Evaluation of the report by Tokyo Electric Power Company regarding the leakage from a connection valve between A5 tank and A6 tank in the G4 South Tank Area at the Fukushima Daiichi Nuclear Power Station

Nuclear Regulation Authority, Japan
17 June 2015

Figure 2 Appearance of the Valve (extracted from the TEPCO report)

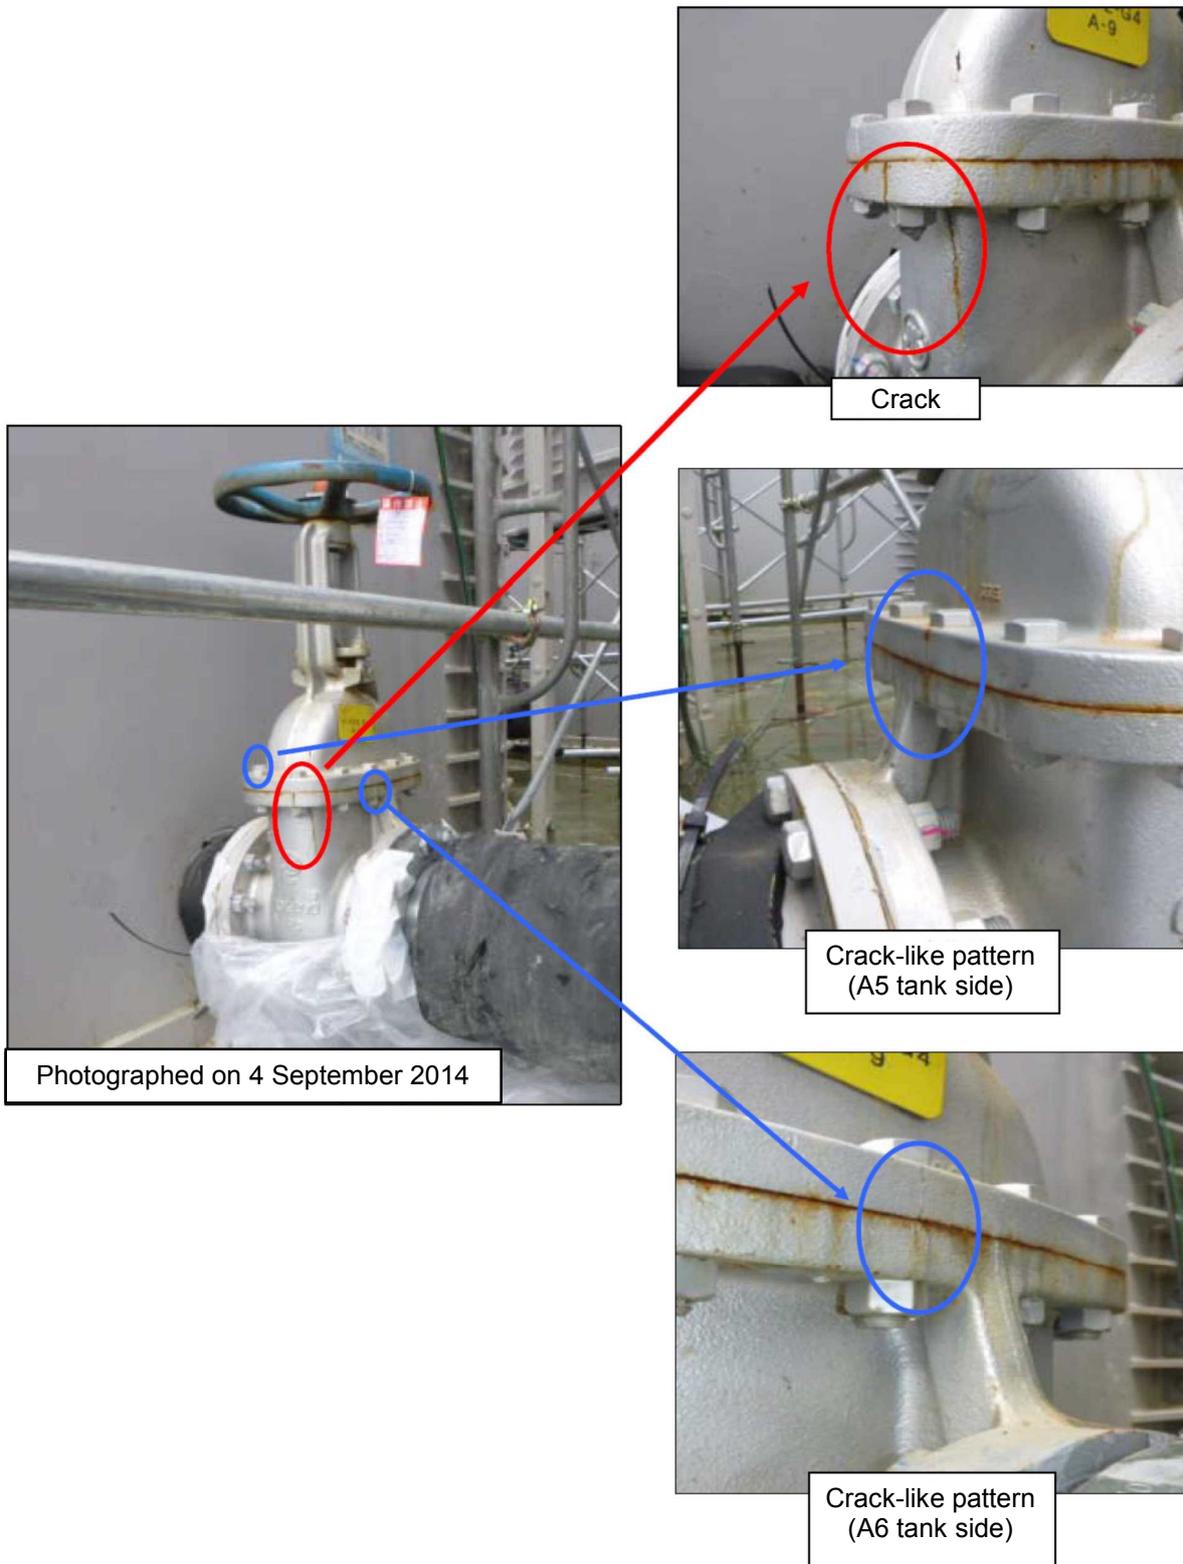
The number of days when the minimum temperature of the outside air within the Nuclear Power Station site marked below-freezing points between late December 2013 and the end of March 2014 amounted to 61 days, out of which 4 days recorded -5°C or lower. Notably, from around 22:00 5 February 2014 to around 5:00 the next morning, the outside air temperature was constantly -5°C or lower. Because of such low temperatures, it is presumed that the sealed chamber of the Valve cooled from the inside, and the filtered water remaining inside the sealed chamber froze and its increased volume caused the through crack.

On 4 September 2014, while the RO-concentrated water was being transferred to A5 tank, the water leaked from the through crack of the Valve.

The Valve that produced the through crack was replaced with another valve of the same type on 13 September 2014. The same type of valves on the RO-concentrated water lines outside the dikes and inside the dikes of contaminated water tanks was visually inspected by removing thermal insulators from 26 September to 13 November 2014, and no problems were found.

Figure 3 Leakage from tanks (extracted from the TEPCO report)

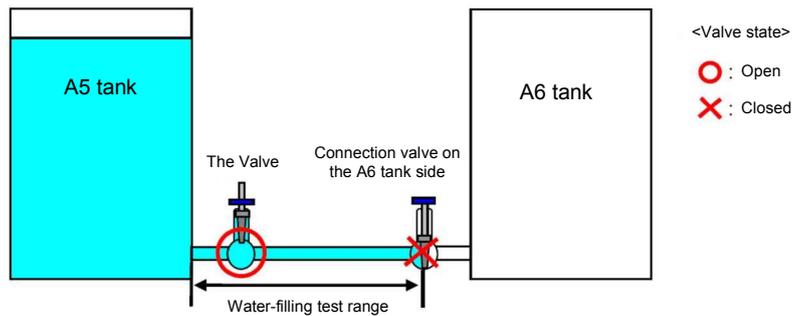
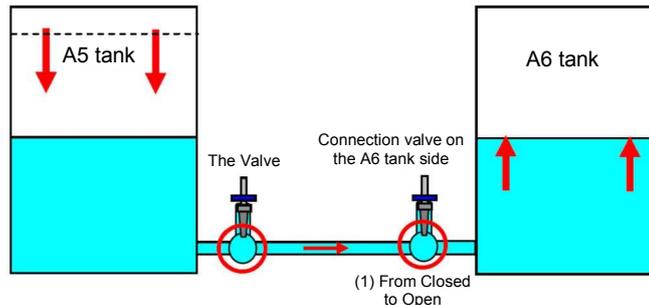
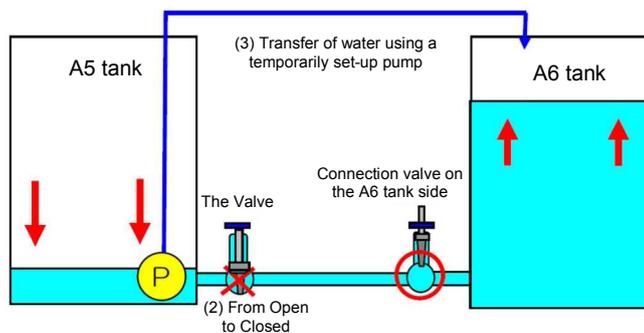
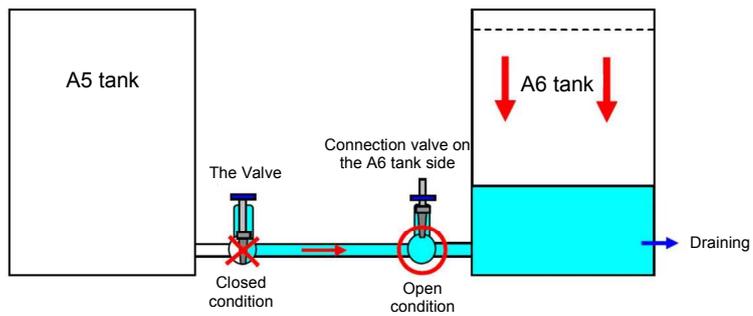
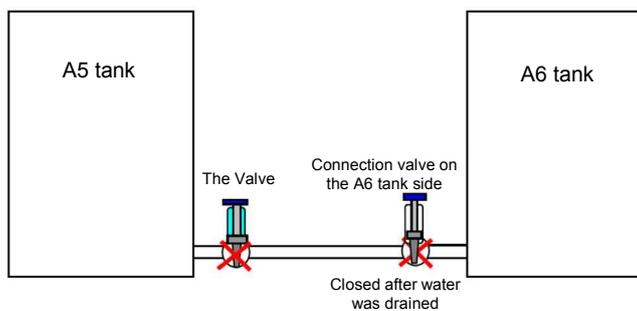
It was found that the Valve was closed during a draining of the connection pipes following a water-filling test for A5 and A6 tanks in November 2013. As a result, the sealed chamber remained filled with filtered water (refer to Figures 3 and 4). Despite the fact that thermal insulators were installed to the Valve and the connection pipe, due to the close proximity of the Valve to the A5 tank, they were virtually exposed to outside air via the tank (refer to Figure 4).

Related departments were instructed to inscribe in their Testing and Construction Work Manual, the procedures for draining the sealed chamber of valves when draining the connection pipes after conducting water filling tests for contaminated water tanks and connection pipes.

Figure 4 The sealed chamber of the Valve and cooling condition
(extracted from the TEPCO report)

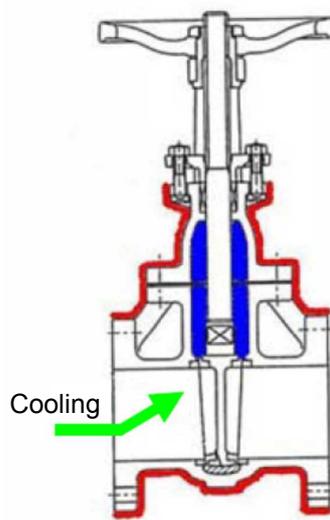
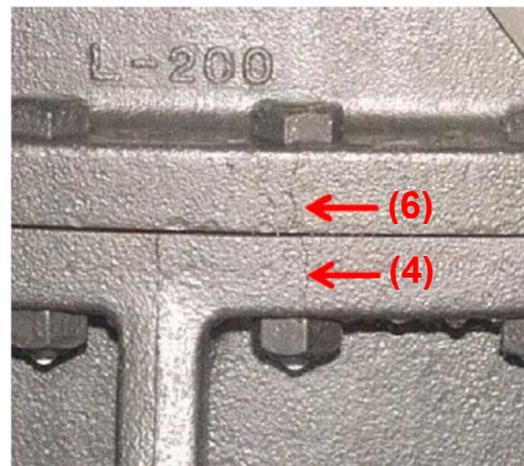
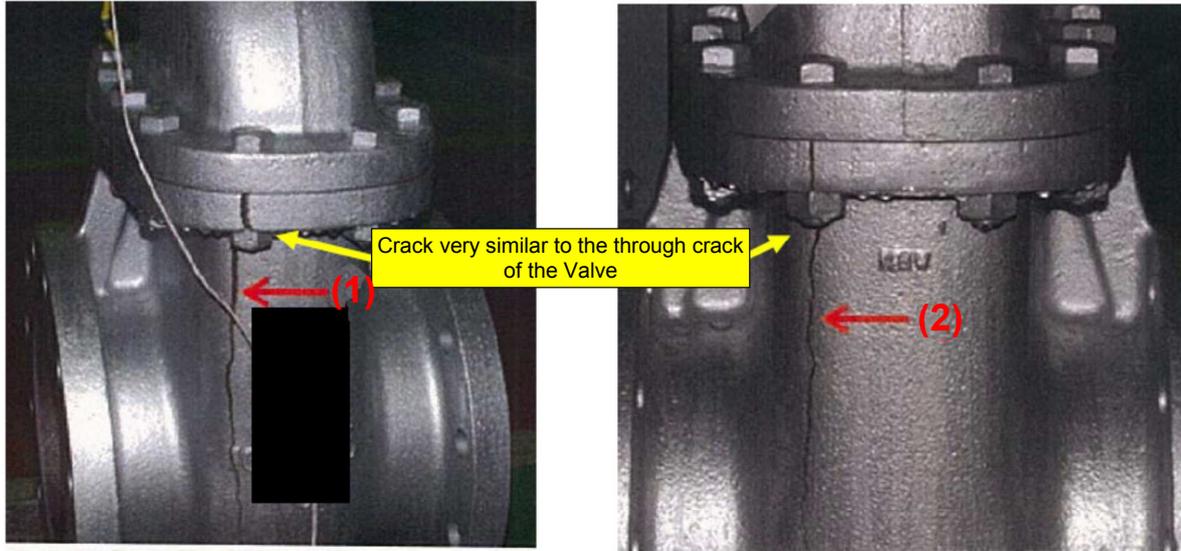
The sealed chamber was exposed to outside air that came in through the air bleeder tube of A5 tank, and the chamber was likely cooled from inside of the valve. Due to this condition, the thermal insulator attached on the outside of the Valve did not work effectively.

The A6 tank side of this sealed chamber was not directly exposed to outside air because the connection valve on the A6 tank side was in the closed position.

Figure 5 Results of a test that reproduced generation of through cracks due to freezing (extracted from the TEPCO report)

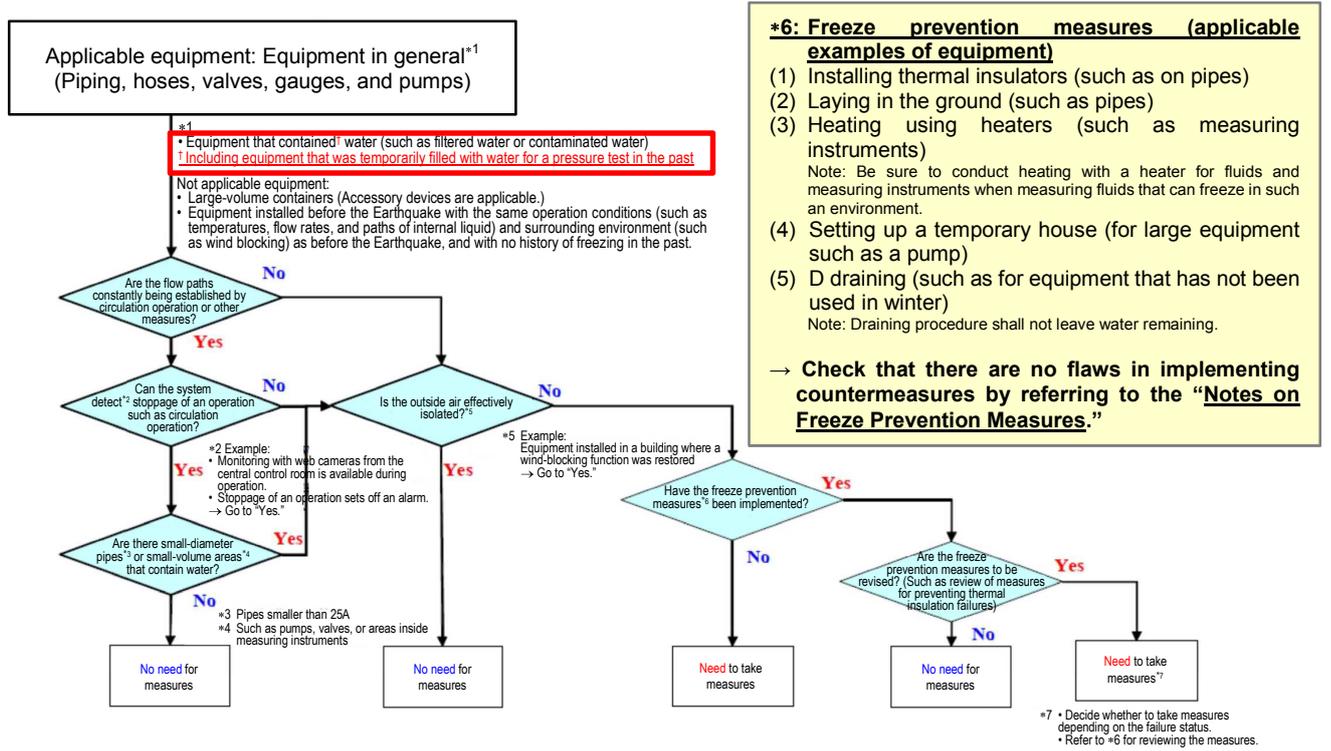
The manufacturer of the Valve investigated past similar incidents, and as a result, found an incident where liquid remaining in the sealed chamber inside the Valve box froze and its increased volume applied excessive stress that generated a crack. A valve of the same type with its sealed chamber full of water was tested by leaving it at an ambient temperature of -10°C . When the temperature on the surface of the Valve box reached approximately -5°C (around 6 hours and 20 minutes from the start of the test), a crack resembling the through crack which caused this incident appeared (refer to Figure 5).

Cracks were found at six points (1) to (6).
